PRELIMINARY/FINAL DRAINAGE REPORT

JUDGE ORR ROAD RV PARK & STORAGE DEVELOPMENT

**ADP Project No.160301
November 6, 2018**

PCD Project #PPR-16-040

DETENTION BASIN STAGE-STORAGE TABLE BUILDER

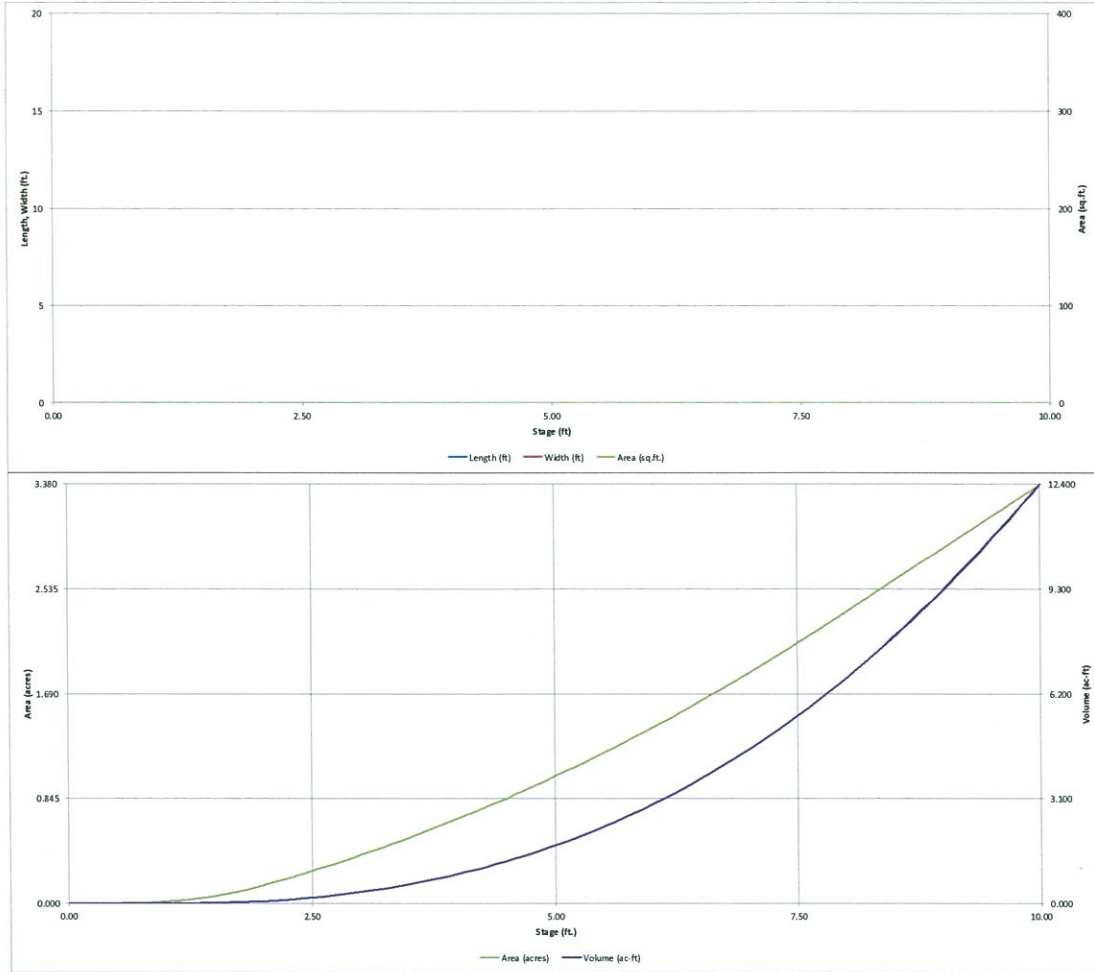
Revise the Pond 2 stage-storage based on the constructed pond shape shown on the GEC plan and not the computer generated values. Input the values in the "optional override stage/area".

The auto-generate for Pond 1 is okay since it was mainly for modeling the pond in a series based on an assumed condition for Pond 1.

However, add a statement that with development of pond 1, that drainage report will have to provide the same pond in a series analysis to verify release rates still meet Senate Bill 15-212.

12/4/18 Unresolved.

DETENTION BASIN STAGE-STORAGE TABLE BUILDER

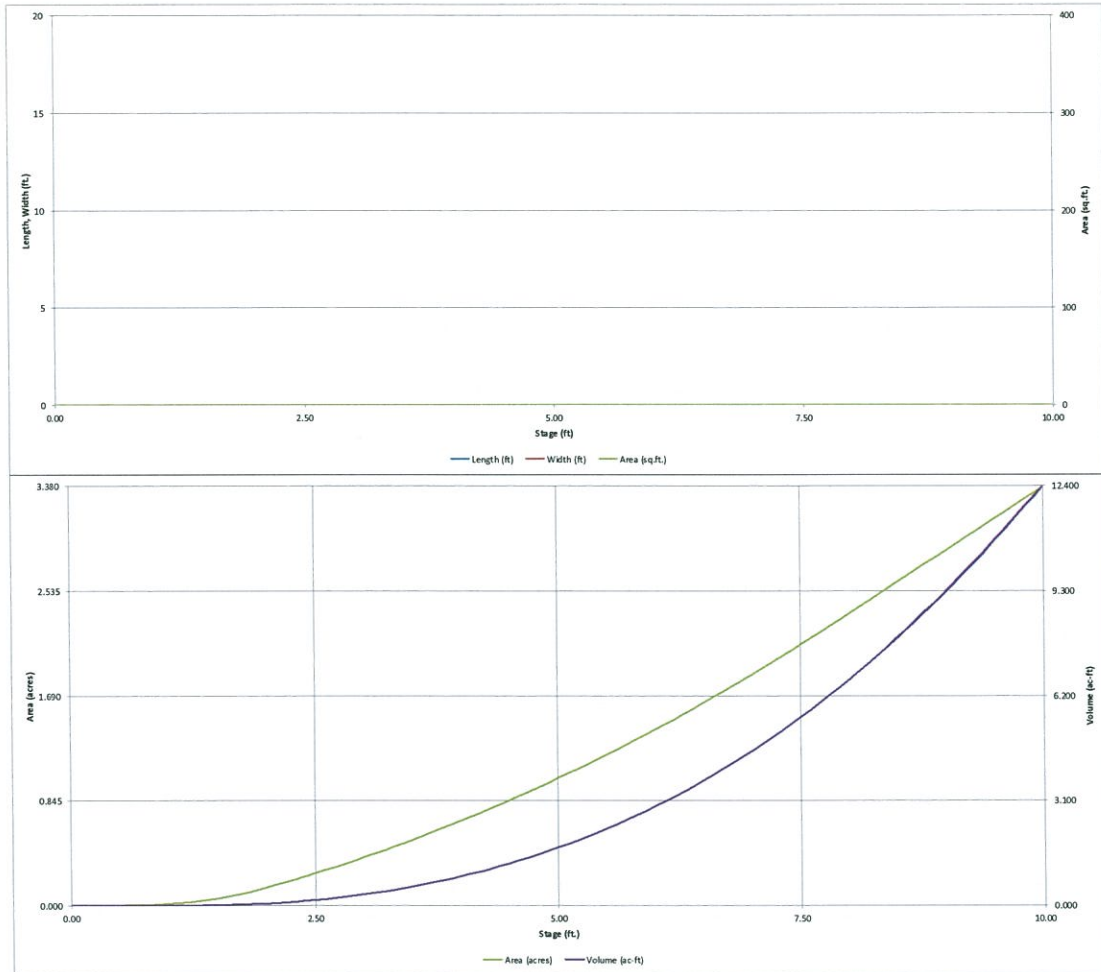
Update title. Staff assumes this is Pond 2 design (w/ Pond 1 & 2 in a series).

Detention Basin Outlet Structure Design

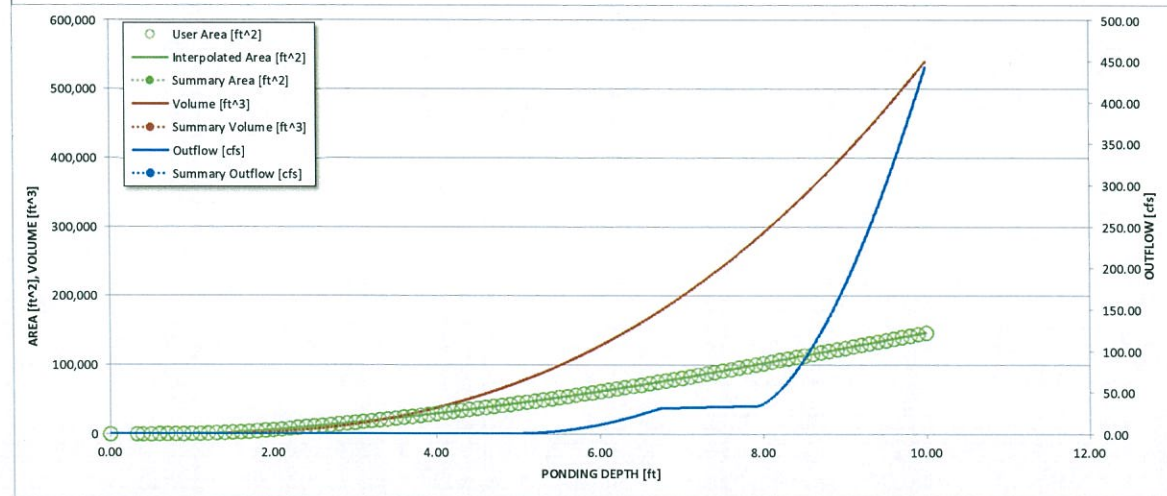
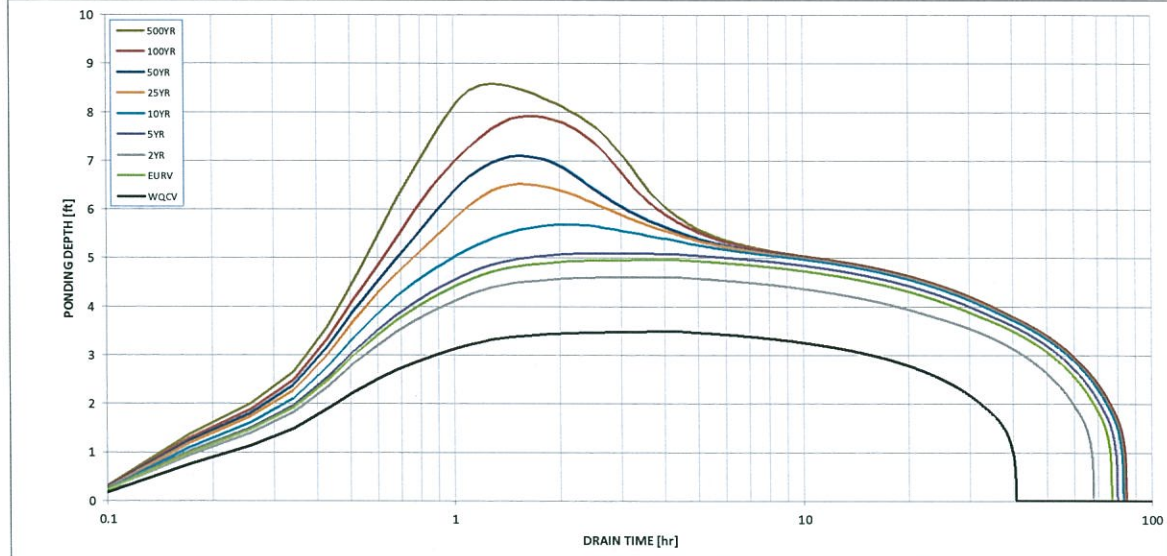
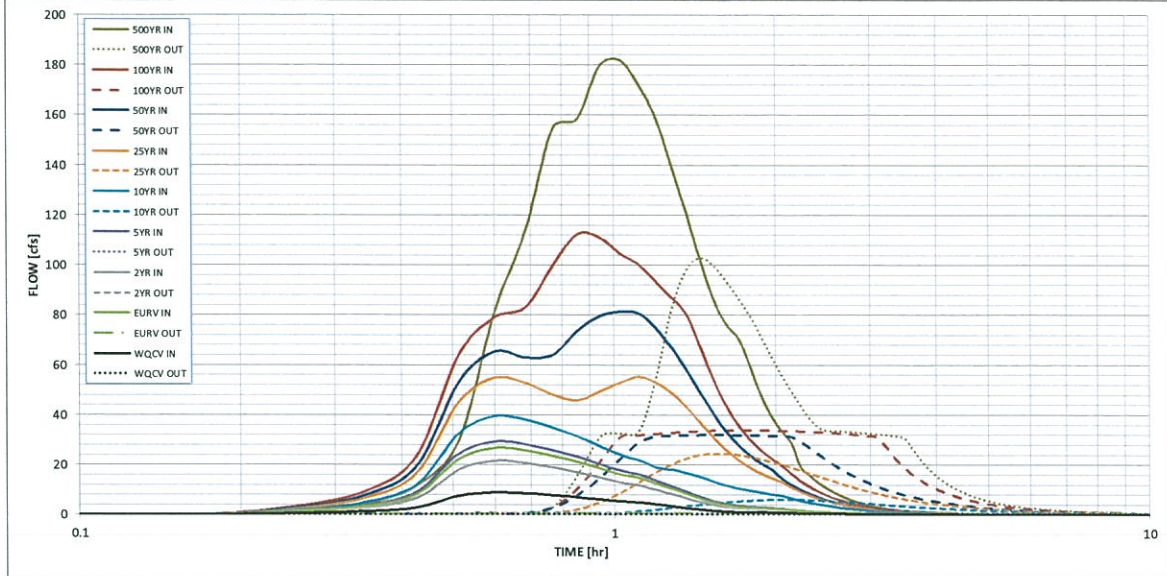
Unresolved. Update to release at or below historic for the full spectrum detention. As the outlet structure is modified for the release ensure the drain time does not exceed the state statute criteria (5yr to release 97% w/in 72hrs).

should fully release in the outlet structure.

CULVERT DESIGN FORM
 DESIGNER/DATE: ASB / 5/21/18
 REVIEWER/DATE: _____ / _____

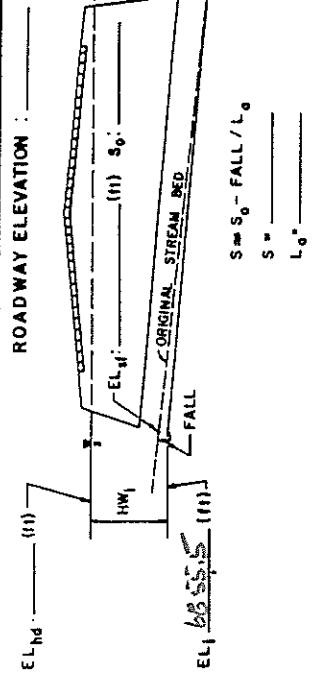
Provide the analysis for overtopping on a Major Storm. Must meet the criteria per Table 6-1 & Table 6-4: Where cross pans are allowed, the depth of flow shall not exceed 12 inches at the flowline.

Update. Drainage map notes 57.3 cfs

Unresolved - dsdlaforce
 12/04/2018 2:34:11 PM

PROJECT: JUDEE ONE RD BY CANY
EAST CULVERT

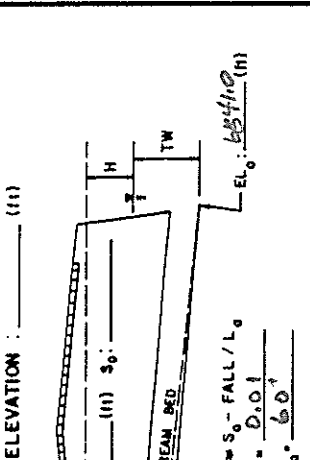
Provide the analysis for overtopping on a Major Storm (per drainage map Q=62.4 cfs). Must meet the criteria per Table 6-1 & Table 6-4: Depth of flow shall not exceed 6 inches at the edge of the road shoulder. Similar comment for the east culvert.

SHEET
1 of 3

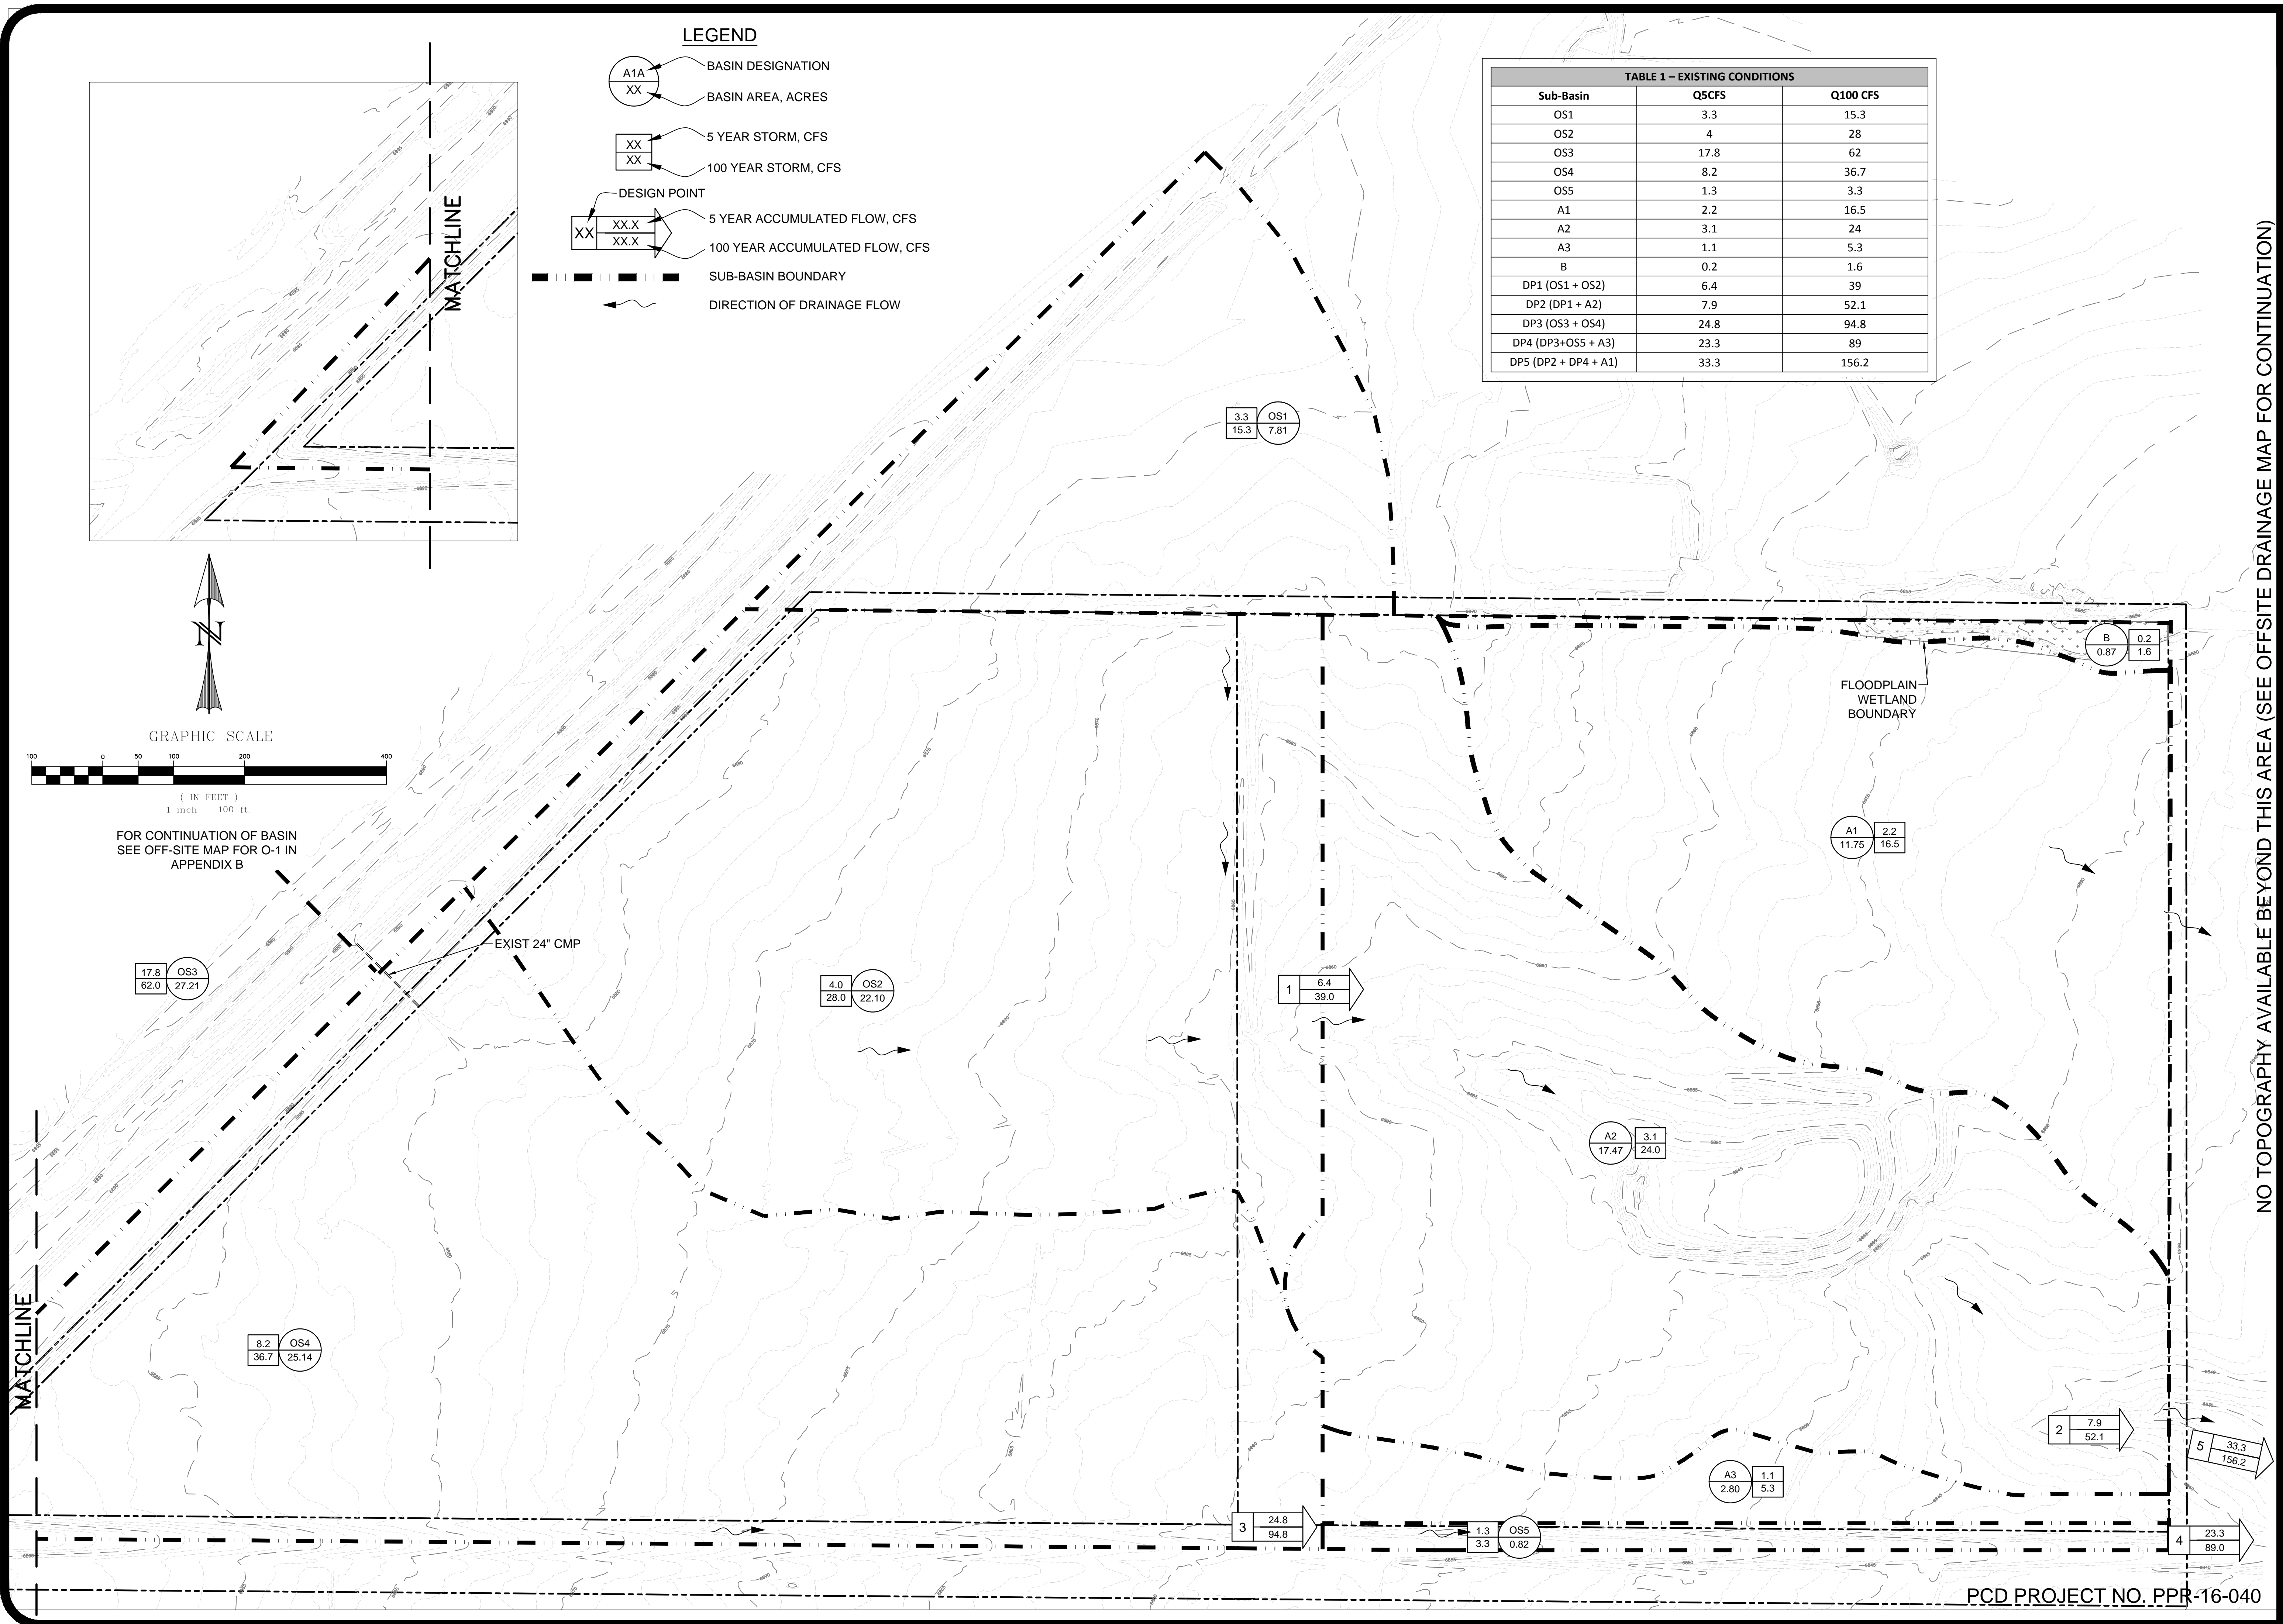
In the developed condition (pg 4) it noted off-site area remains the same. The design engineer noted on the 8/8/18 meeting that the intent was to pipe OS3 through basin OS2 and discharge to the Judge Orr ditch and not flow within the revised OS2 basin boundary shown on the proposed drainage map.

Update the narrative to discuss and provide analysis for the diversion. Is the ditch still hydraulically adequate with the reroute?
